This brochure compromises of the proposed design changes to Block A and Phase 1A, which are submitted as a non material amendment to Reading Borough Council.

Block A forms part of a much wider scheme relating to the redevelopment of the St MartIn's Precinct in Caversham which was granted planning permission on 31 March 2015 with Reference No.140997. Block A was redesignated as Phase 1A in a Deed of Variation to the S106 agreement dated 20 April 2017.

3.0 Proposed revised design comparison

Previous Phase 1A car parking - annotated

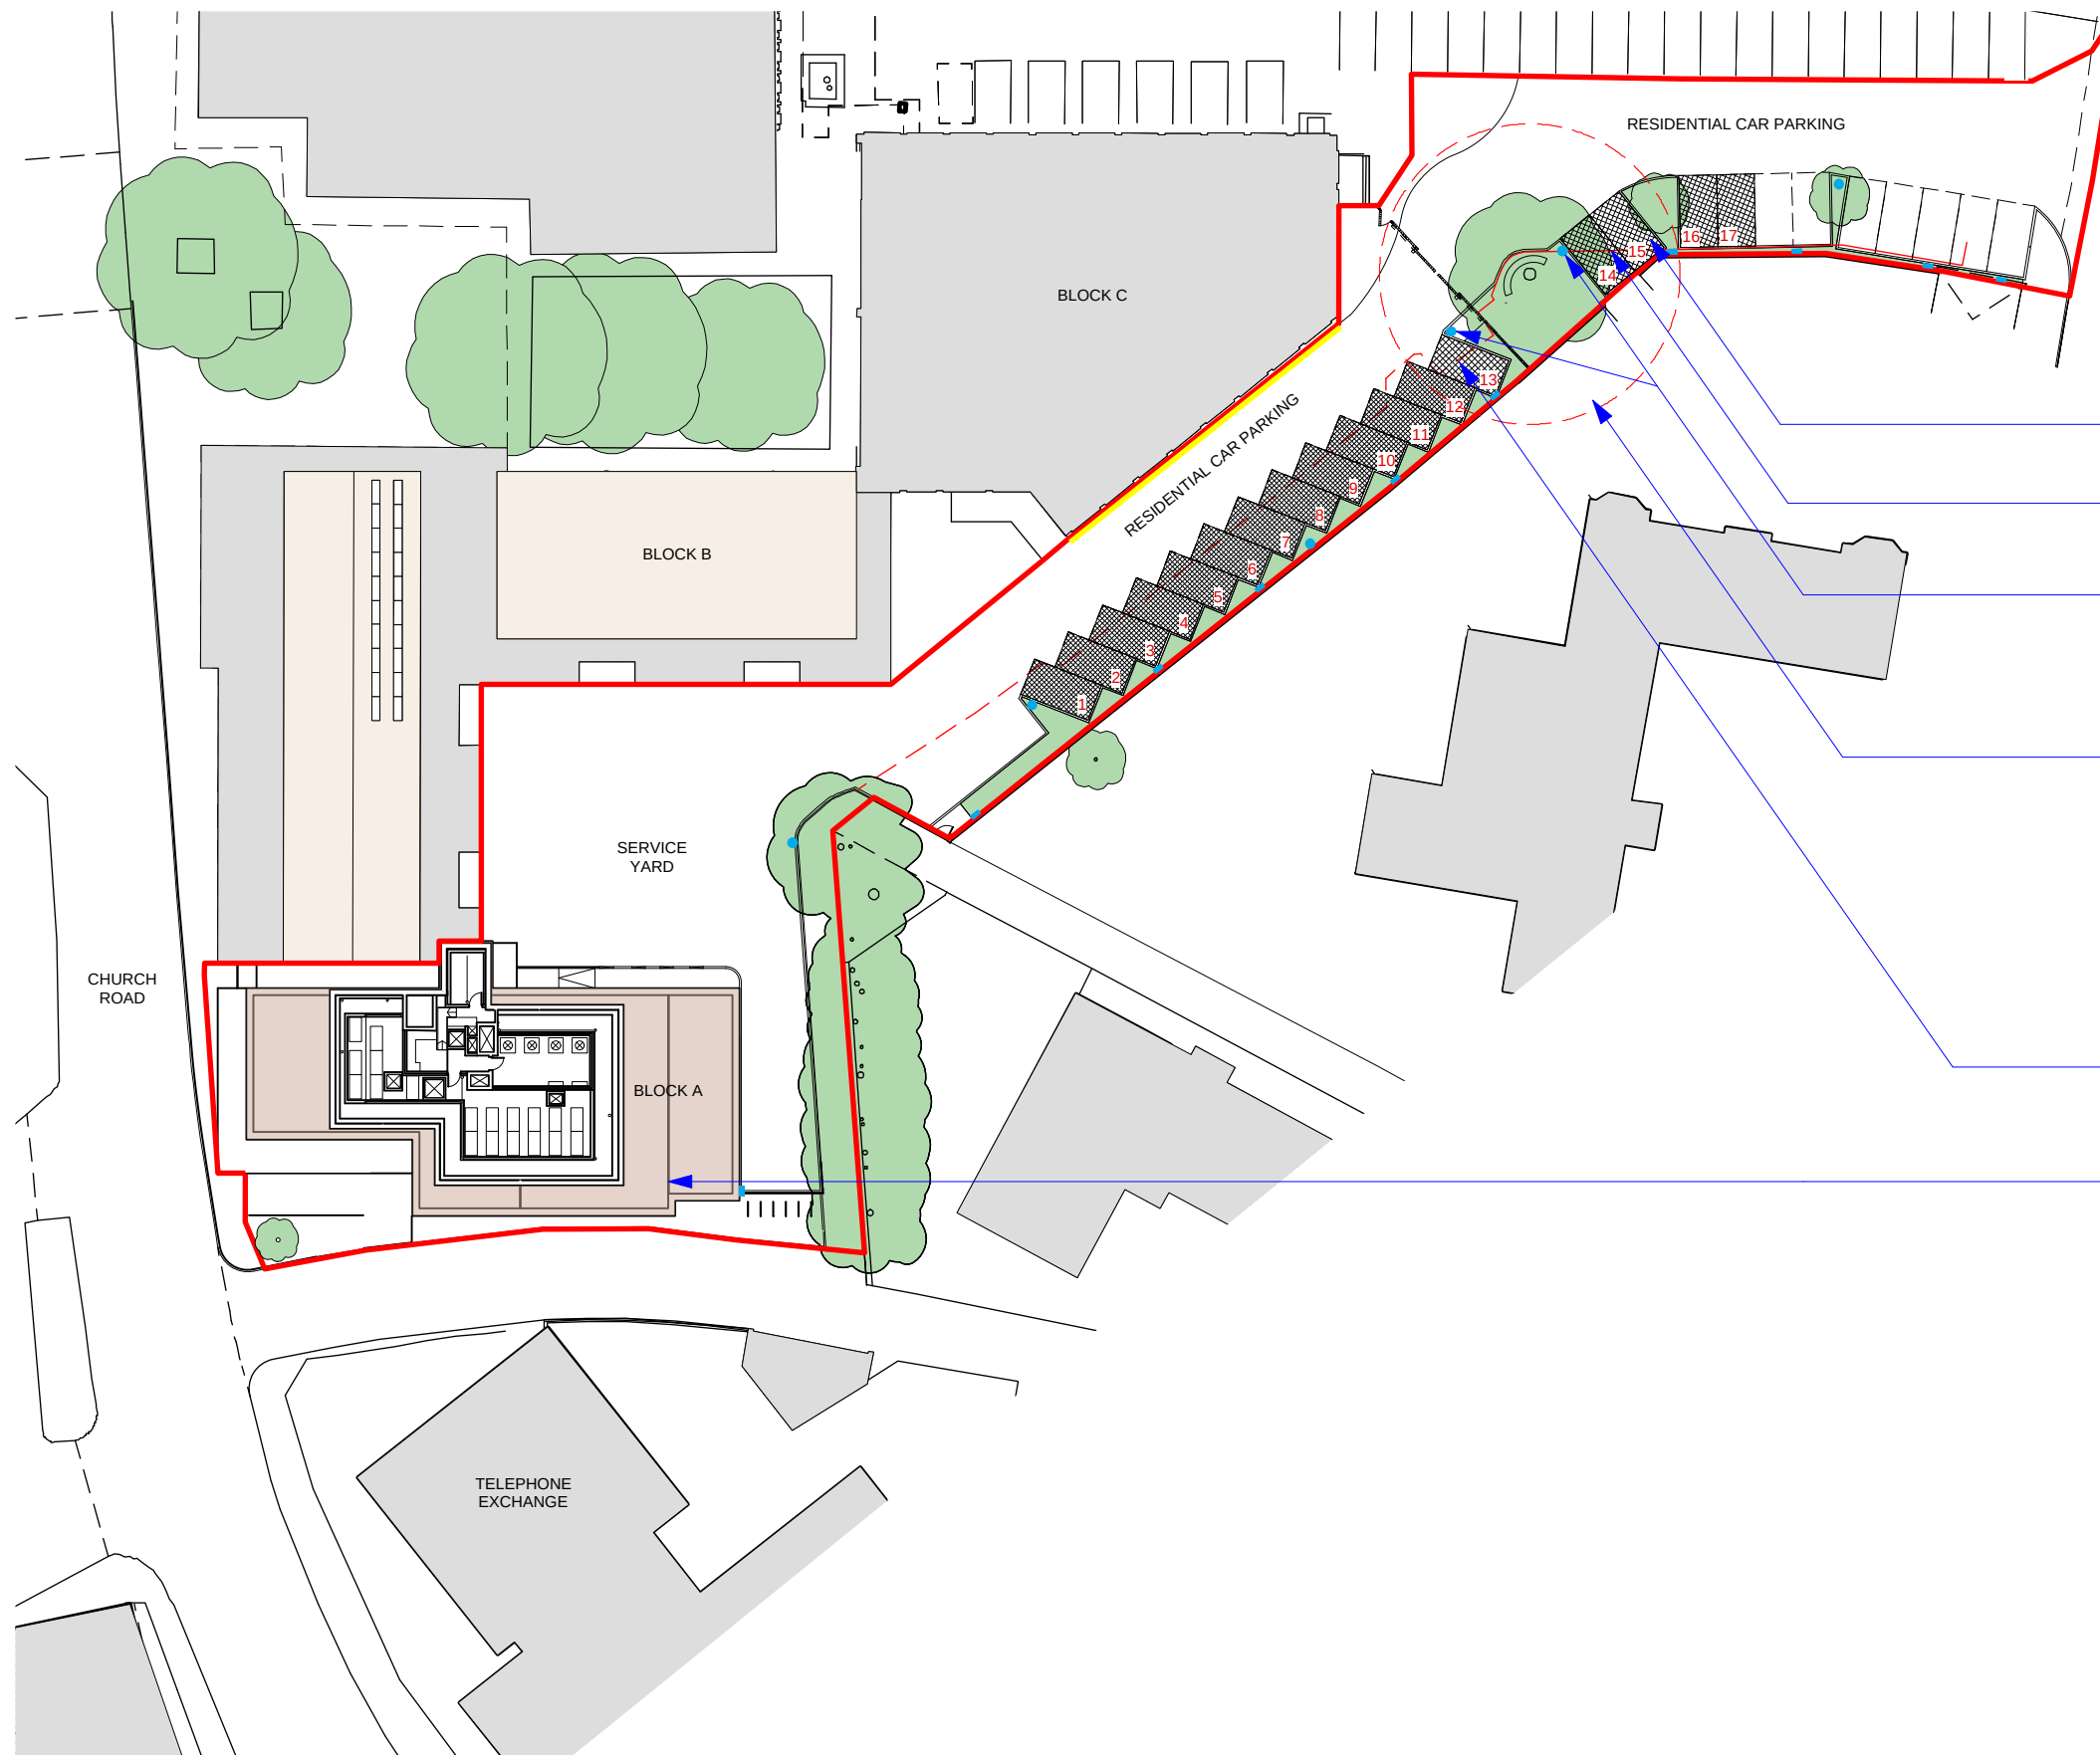
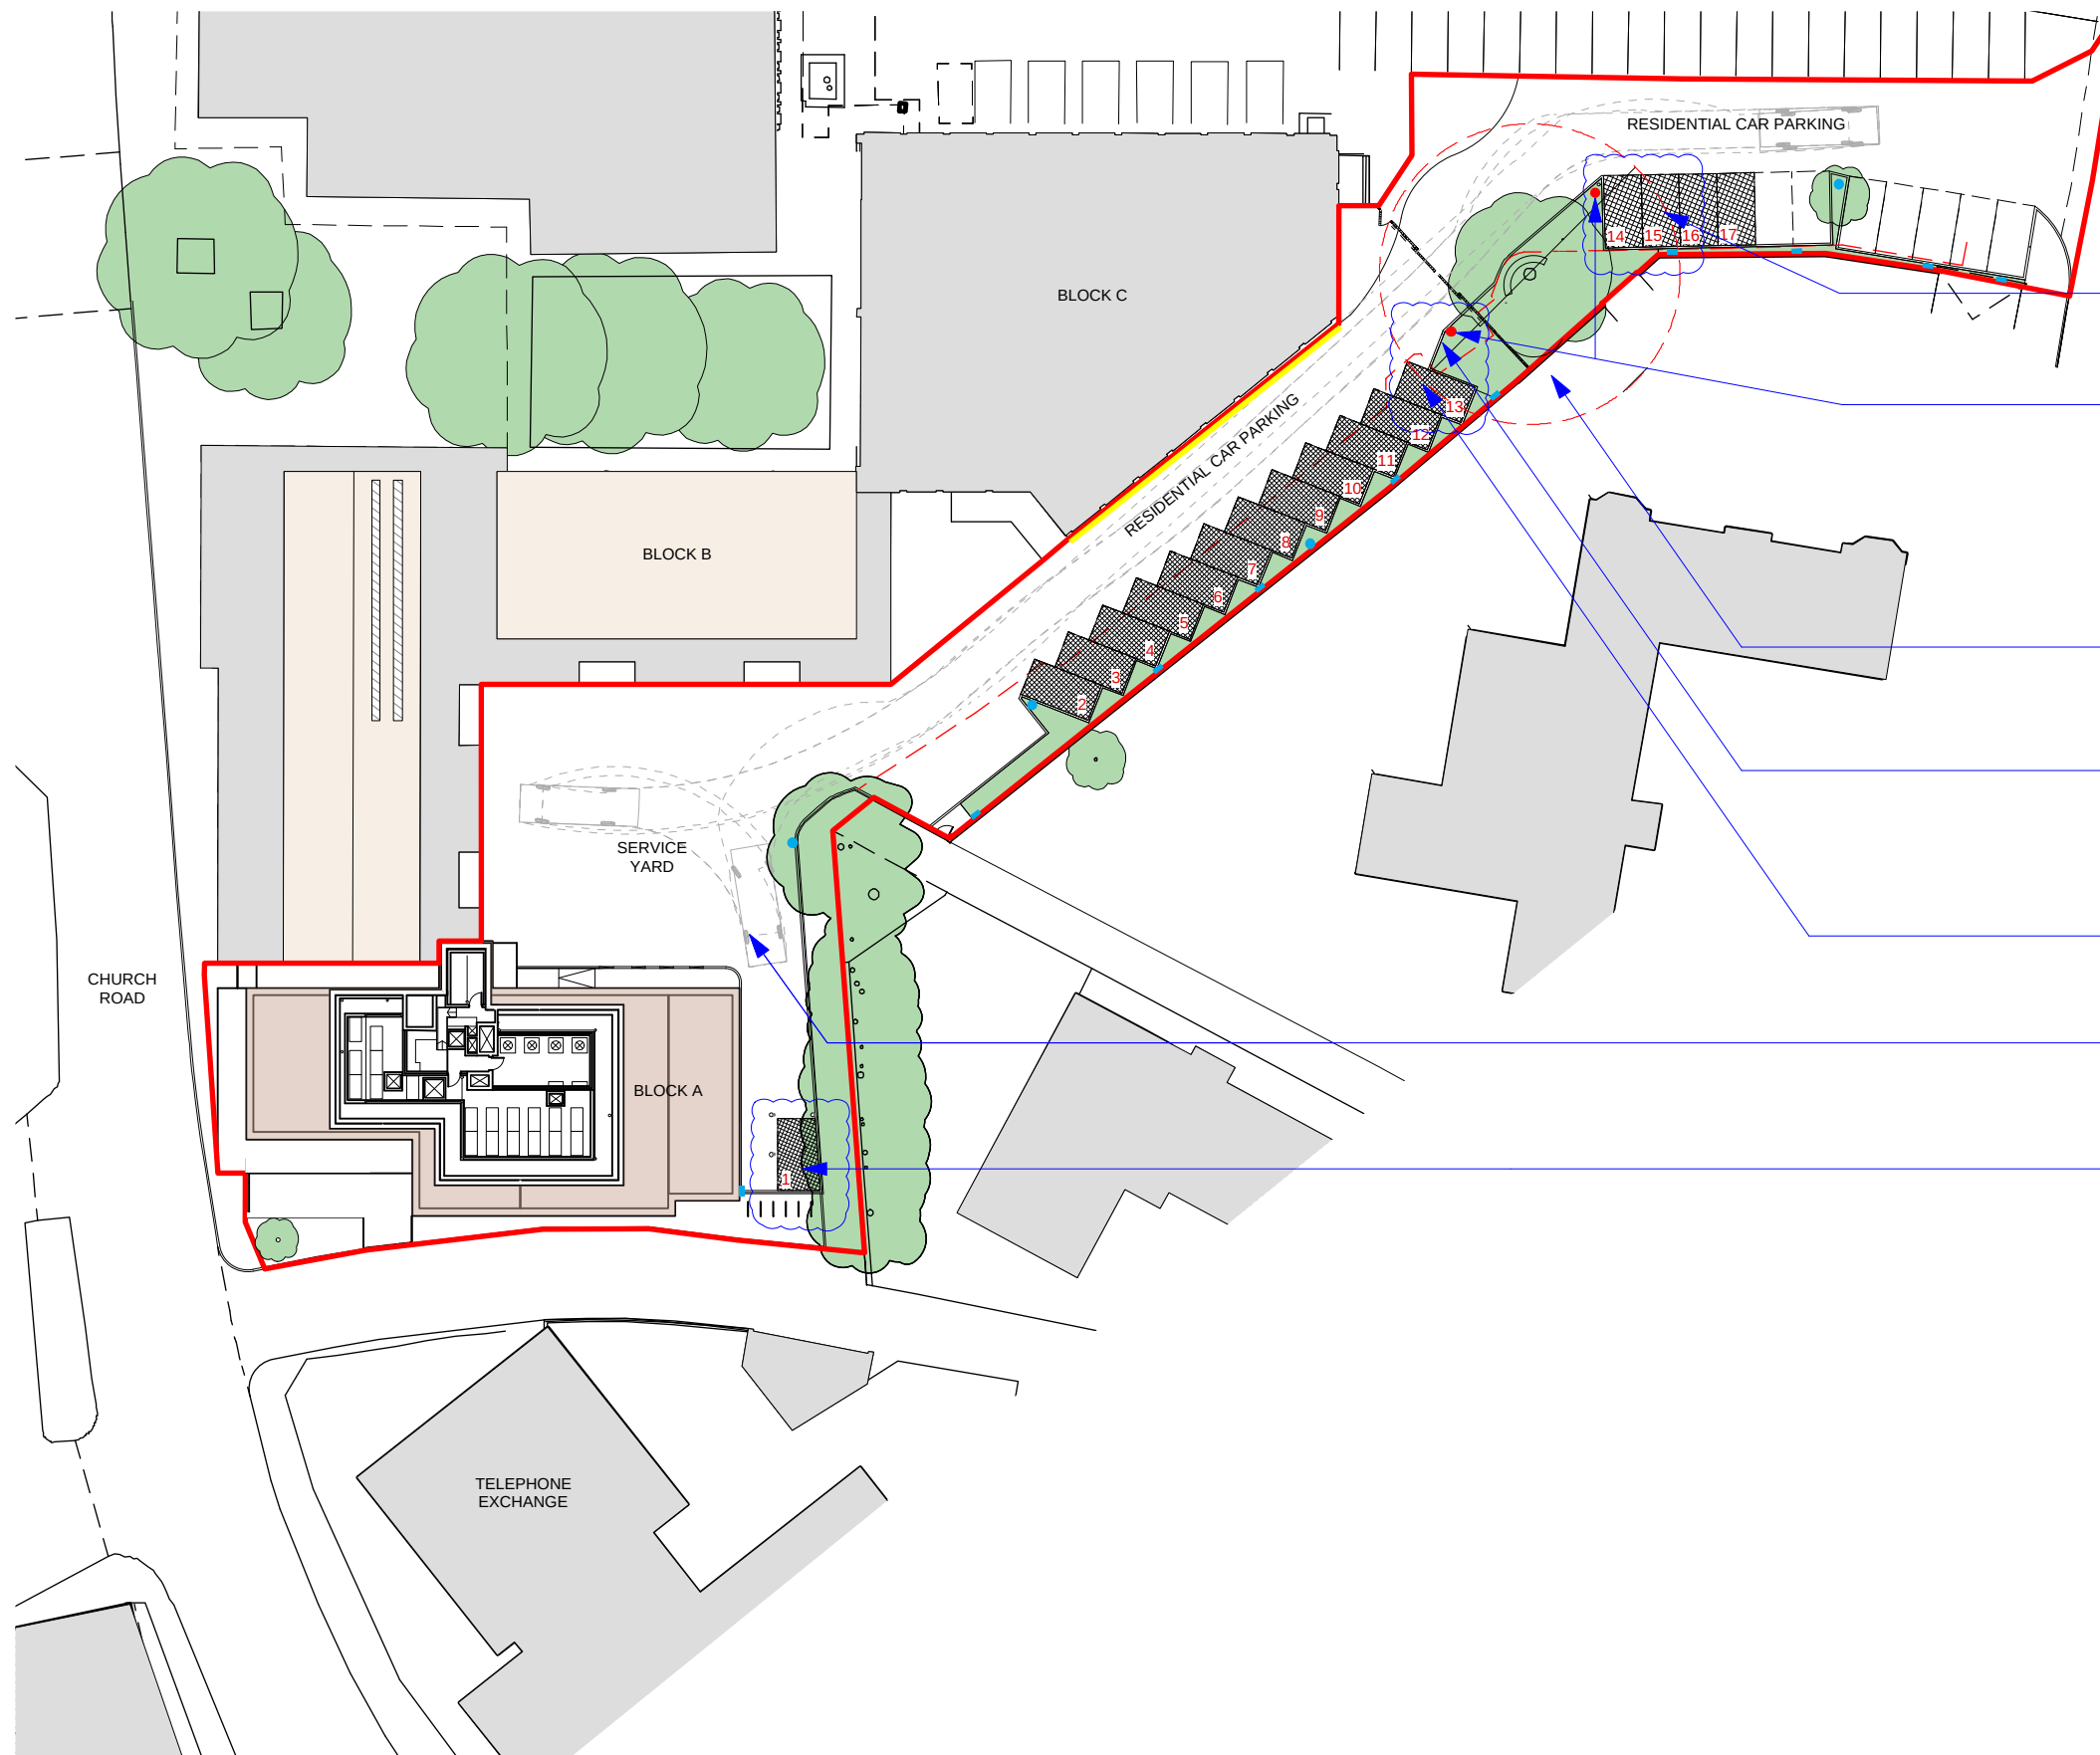
The previous approved planning drawing proposed a car parking layout that was not capable of being implemented in a limited number of areas due to issues either with site levels or because of the impact on the existing tree to be retained.

Spaces 14 & 15 reside fully within the tree root protection zone and partly upon the existing soft landscaping, this would require a raised cellular confinement system to construct the parking spaces. This would make the level of the spaces approximately 300mm above the existing level of the access road. This will cause difficulty in tying into the existing levels and drainage.

The foundations required for the proposed locations of the lampposts could cause issues as they are located within the tree root protection zone.

Tree root protection zone with a radius of 10m around the existing tree as advised by the arboriculturist (FLAC). Any spaces located within the soft landscaping area are required to be constructed using a raised cellular confinement system upon the existing soft landscaping levels. This will cause difficulty and will not work with the existing access road levels.

Only space 13 fully resides within the tree root protection zone, located upon the area of existing soft landscaping, therefore the space would require to be constructed using a raised cellular confinement system. This would make the level of the space approximately 300mm above the existing level of the access road. This will cause difficulty in tying into the existing levels and drainage. Whilst space 12 partly resides within the root protection zone it is only on the periphery of it and the arboriculturist has confirmed that in this location the impact on the roots caused by the limited excavation to create the new space will be negligible and its location can remain as previously proposed.

The original scheme had 3no. car parking spaces below the undercroft. The undercroft has now been removed and the ground floor arrangement amended. The 3no. spaces have been relocated.

Parking spaces 14 & 15 have been rotated to align with 16 & 17. The revised location of the spaces is upon existing tarmac road not soft landscaping. Whilst the spaces are in the tree root protection zone, as they are located on the area of existing tarmac surfacing there is no excavation or works to be done that will come into contact or affect the existing tree roots. The spaces will not require a raised cellular confinement system to be used, as only the existing wear layer of the tarmac is being replaced meaning the existing levels can be maintained.

The lamp posts located within the tree root protection zone has been amend to bollard lights, as these have minimal foundation requirements, which will be less intrusive to the existing tree roots.

1no. space has been removed from beside the gate, to avoid the tree root protection zone. Space has been relocated to behind the cycle storage area to the rear of the building (see parking space 1).

Only space 13 still partly resides within the tree root protection zone and upon existing soft landscaping. The construction of the parking sapce is to be agreed with the arboriculturist so it can be constructed at a gradienti to tie in with the existing access road and drainage. Works to this area are less sensitive due to the distance to the existing tree.

1no. space has been relocated from within the tree root protection zone by the entrance gate to beside the building. The space is to be protected from delivery vehicles by 3no. post / columns.

Proposed Phase 1A entrance gate - access control.

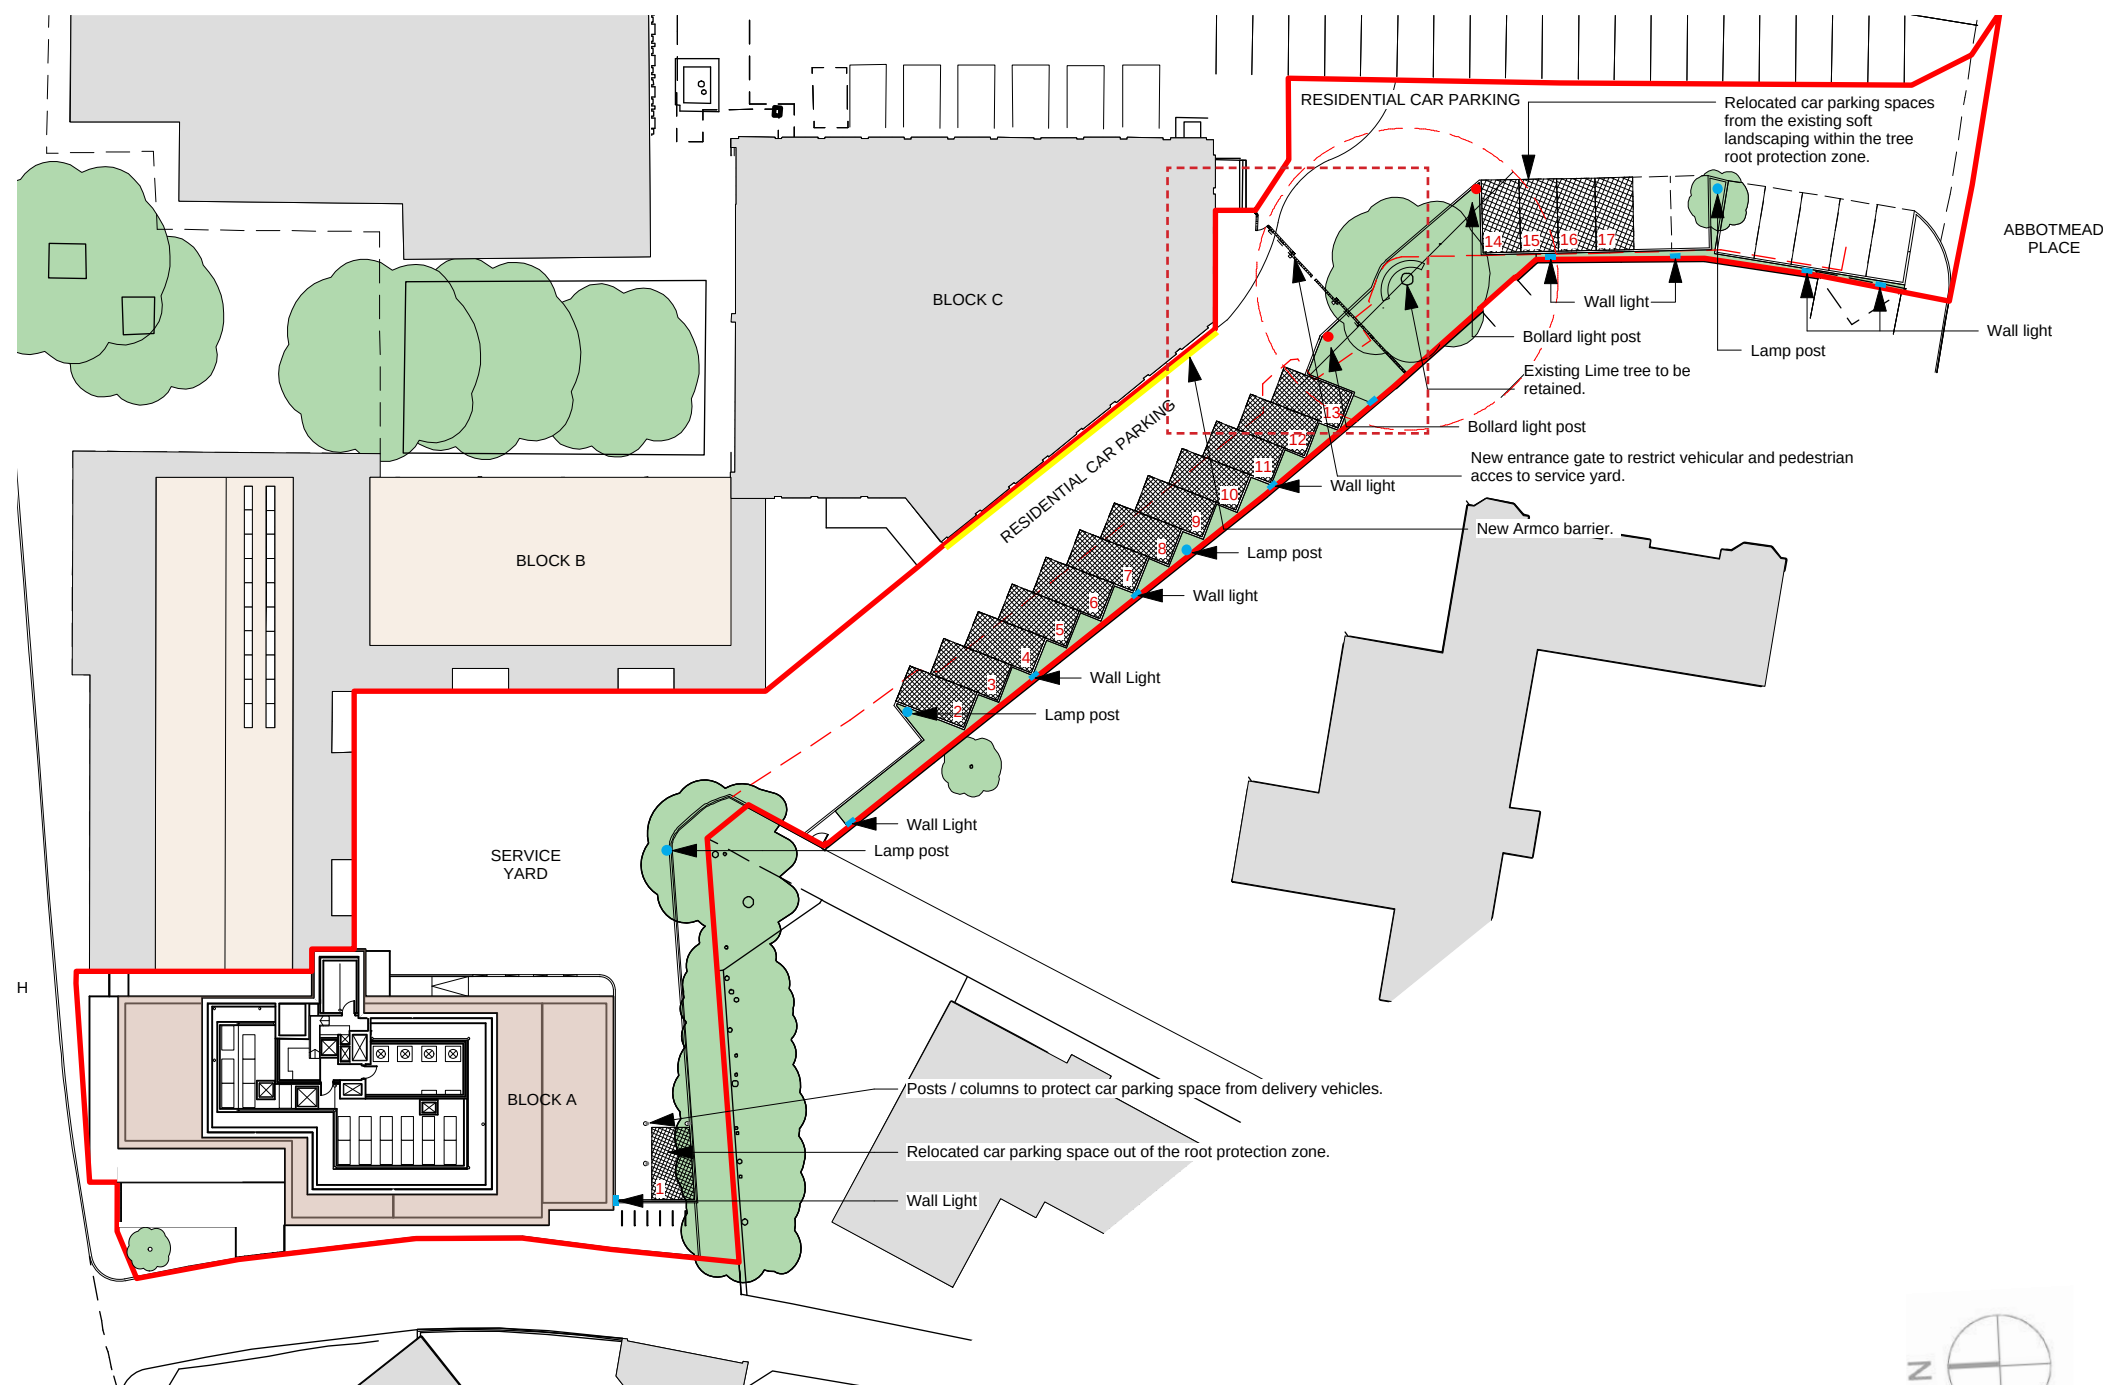
Following the inclusion of the service road within the scope of works for Phase 1A a design for a secure pedestrian and vehicular gate at the rear of Block C has been included to control access into the service yard and parking area for Block A.

Refer to the red dashed box upon the proposed phase 1A site plan for the location of the new entrance gates. Also refer to the detailed proposal for the design of the entrance gate upon the next page.
